1<sup>st</sup> DAM SAFETY INSPECTION REPORT  
of  
**Byevanger Dam**

Owner: Johannes Gerhardus Nel Familie Trust

Report No: C235A-D02-1

DSO No: 12/2/J331/55

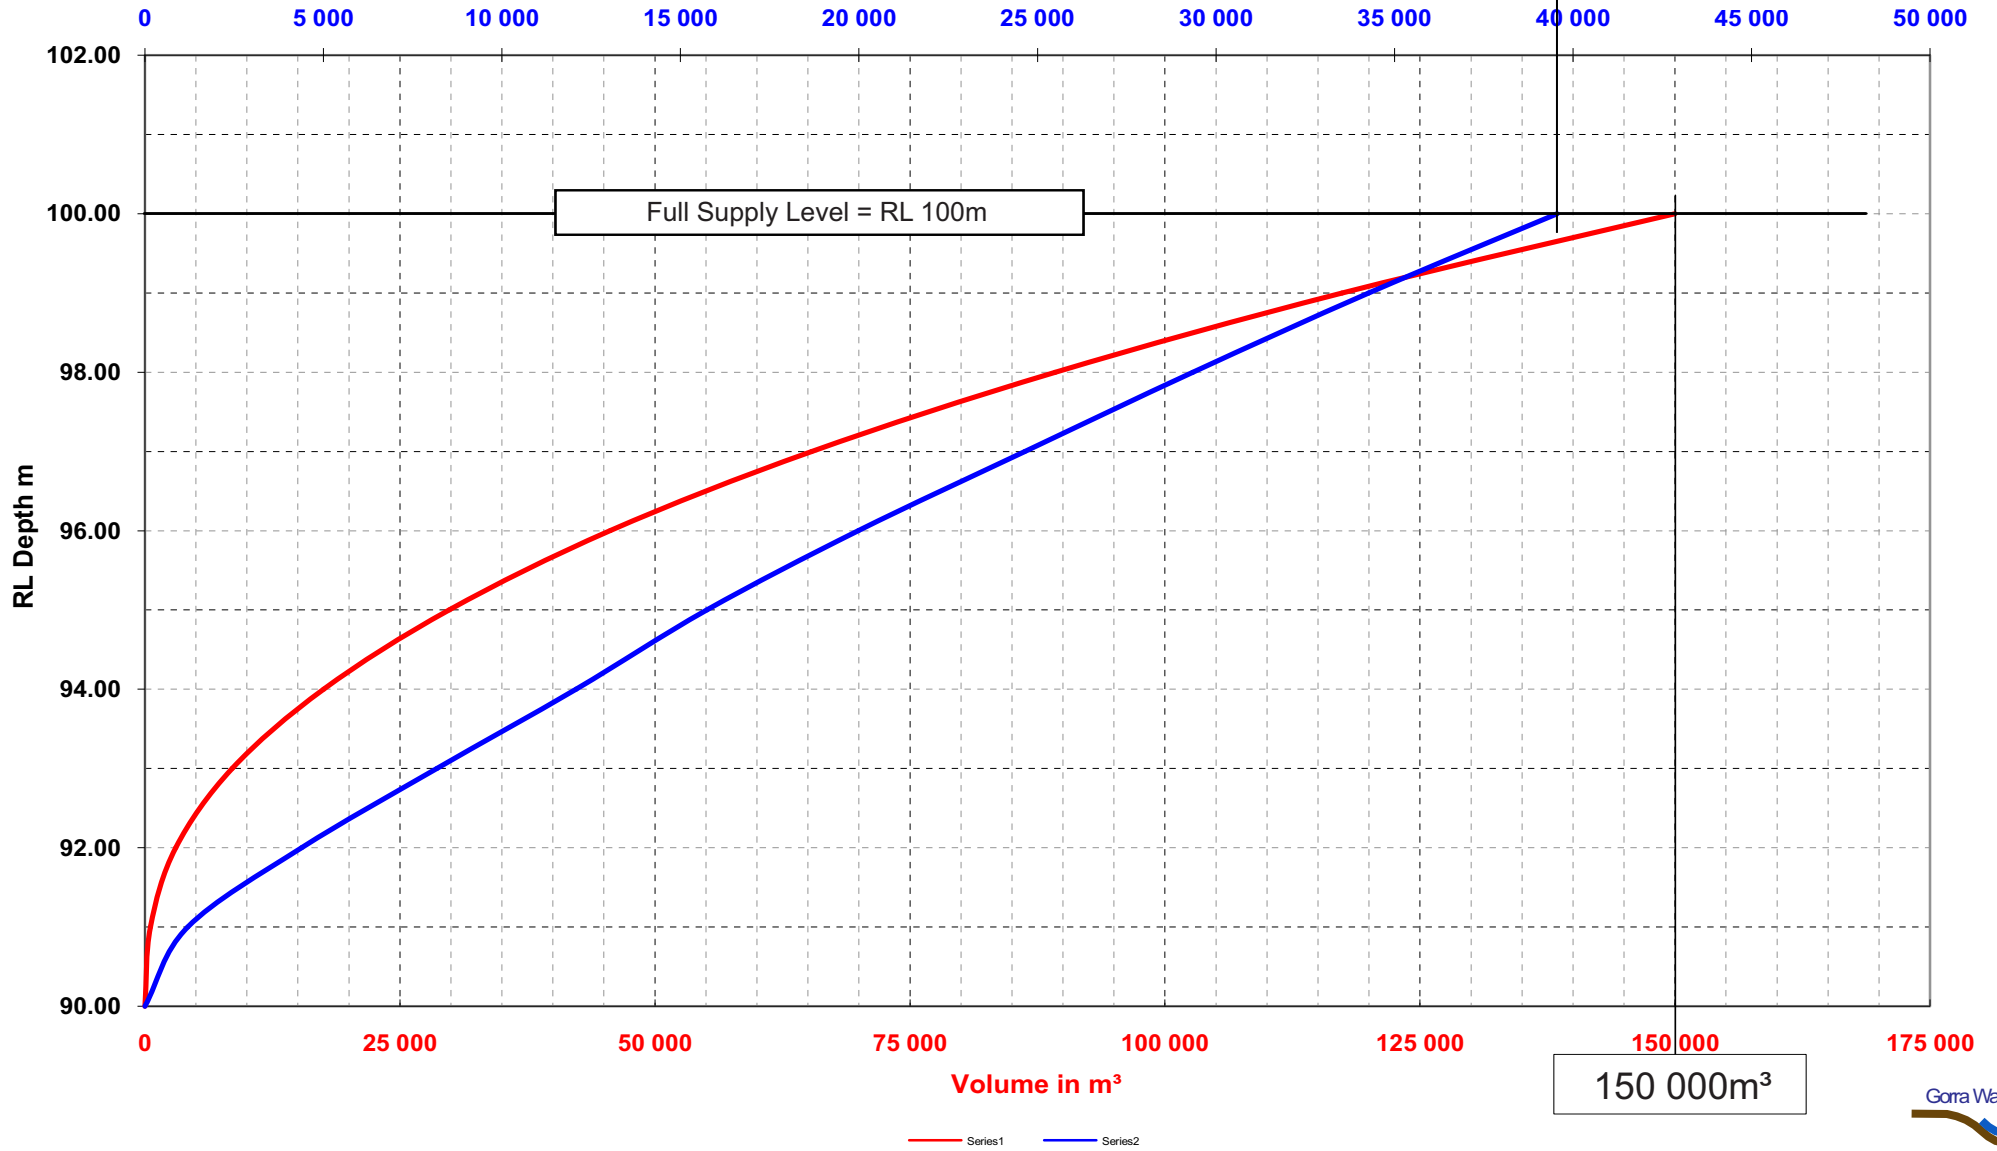
From the above figures it can be seen that the water level during the routed RDF will rise 2.2m above the full supply level at which stage it will be 0.2m above the non-overspill crest. During the routed SEF the non-overspill crest will be overtopped with the flood level at 0.3m above the non-overspill crest.

The non-overspill crest level does not comply with this freeboard requirement and the routed RDF + freeboard factors will overtop the non-overspill crest.

No.	Description of Activity flowing from recommendations	Planned Start Date	Actual Completion Date (only if completed)
1	Urgently adjust the spillway channel capacity to service the RDF flood peak by increasing the freeboard to 2.5m and the spillway crest length to 9m, but complying with the Sec. 24G NEMA and current WULA process.	27 Jan 2020	
2	Provide the upstream slope with rip rap placement as protection against erosion, but complying with the Sec. 24G NEMA and current WULA process.	27 Jan 2020	
3	Fill and compact with appropriate materials the low spots/potholes on the non overspill crest to prevent further degradation, but complying with the Sec. 24G NEMA and current WULA process.	27 Jan 2020	
4	Provide grass growth for the downstream slope to prevent/repair erosion process, but complying with the Sec. 24G NEMA and current WULA process.	27 Jan 2020	
5	Ensure that the dam does not store any water at all to comply with the Dam Safety Office/Environmental directive and to comply with the Sec. 24G NEMA and the current WULA process.	27 Jan 2020

SEF = PMF (Cat.II Small Sig.)

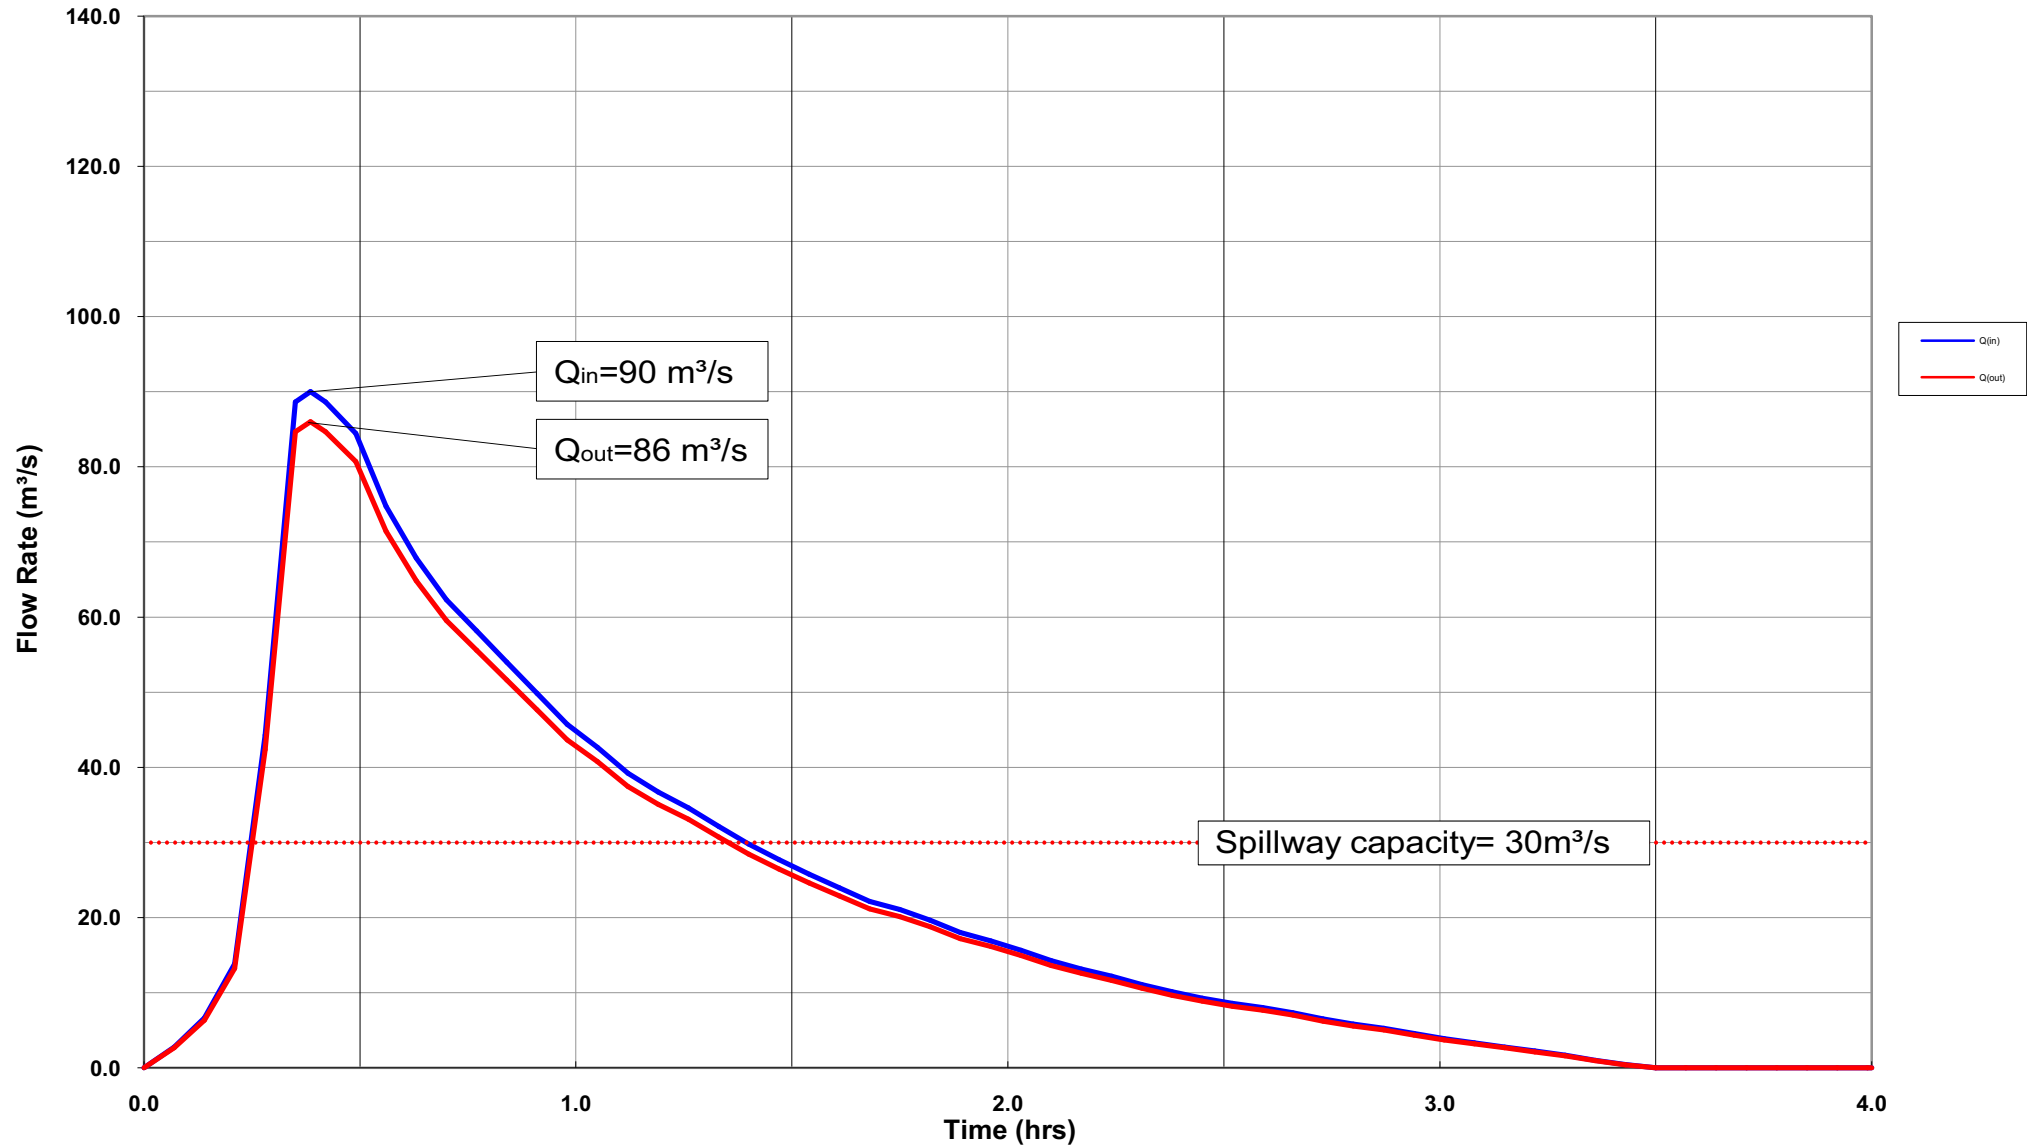
Overtopping at a max flow rate of 56m³/s

**Photo 1**

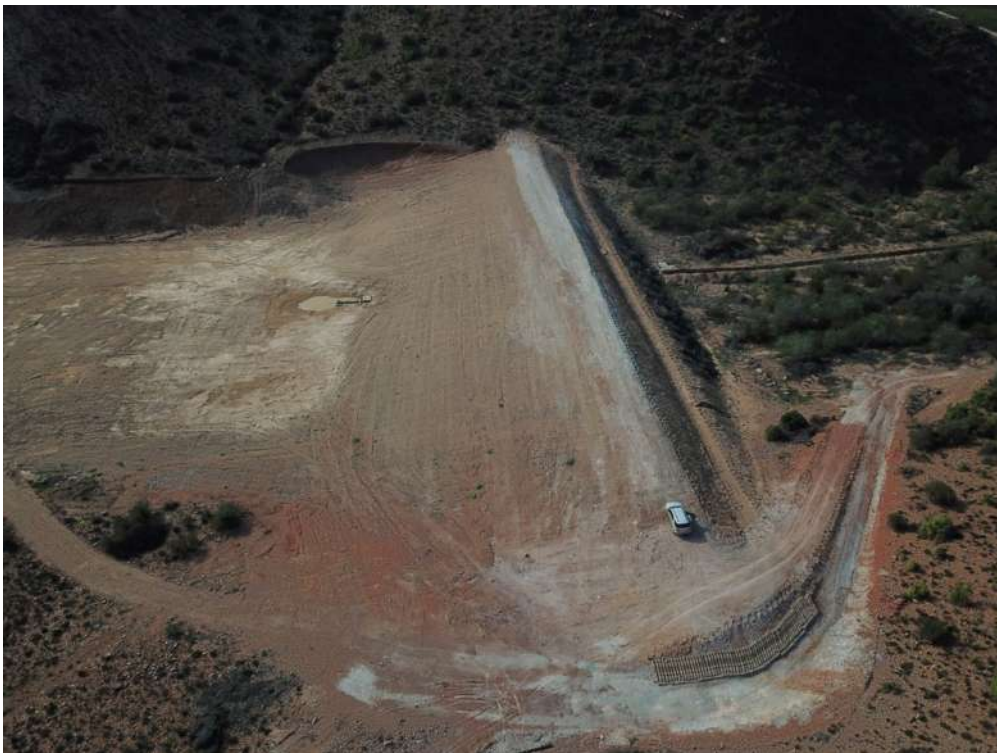
Final evaluation of spillway capacity: The spillway channel was found to be inadequate for the calculated RDF and SEF flood peaks. For the dam to service at least the RDF flood peak, the spillway channel will have to be enlarge by increasing the freeboard and the spillway channel width. (See Photo's 1,3,10-12,16,17)

No structures within the spillway channel, concrete beams are placed on the left retaining wall. Spillway appears stable but too small for calculated flood peaks. (See Photo's 1,3,10-12,16,17)
